City Planning Commission Meeting - May 26, 2015

CONSIDERATION – SUBDIVISION DOCKET – 046/15

Applicant: Detmias Holdings, LLC

Proposal: Subdivision of Lot B into Lots B1, B2, and B3

Table 2: RD-3 District lot requirements and proposed lot measurements

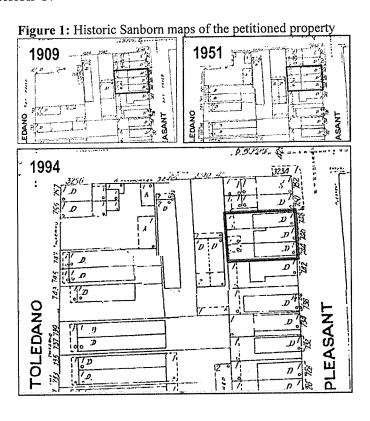
The subdivision of Lot B into Lots B1, B2, and B3 would reduce an already deficient lot further below the lot requirements of the RD-3 District. The proposed lots are deficient in area by 47% to 57%, deficient in width by 12% to 28%, and deficient in depth by 33%. The creation of these lots would create three town house lots that are substantially deficient of lot requirements of the RD-3 District and town house regulations of Section 11.33. Since proposed Lots B1, B2, and B3 are below the minimum lot size requirements, the request does not meet criterion A.

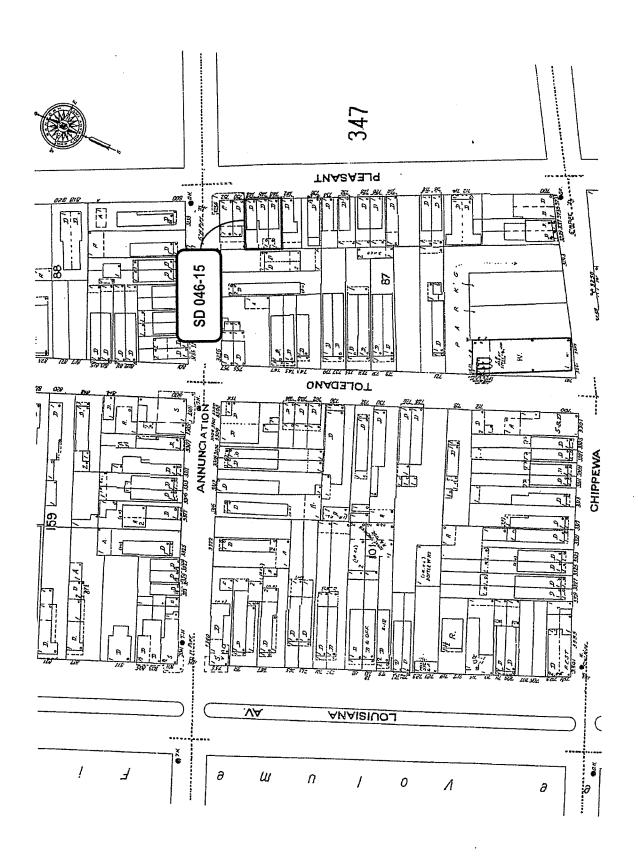
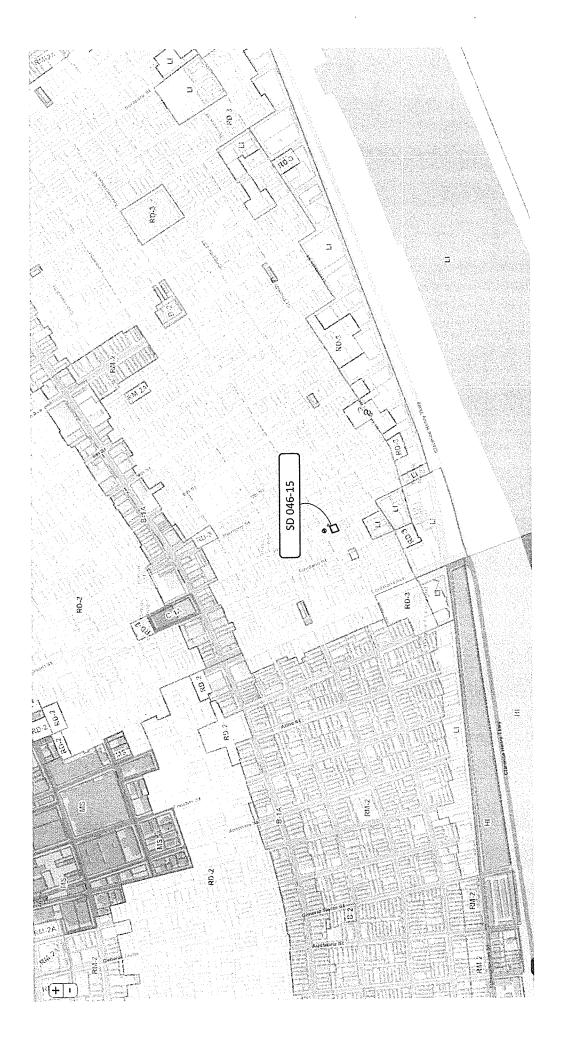
Historic Sanborn maps show the site was developed as early as 1909 with a three-family dwelling, so the site was used prior to the adoption of the Subdivision Regulations in 1950. The three Sanborn maps shown below illustrate that there has been no significant changes to the petitioned site between 1909 and 1994. A two-story addition was constructed at the rear of the historic structure sometime after 1994, but does not appear to have significantly altered the historic structure. Since the existing three-family structure was constructed prior to 1950, the request meets criterion C.
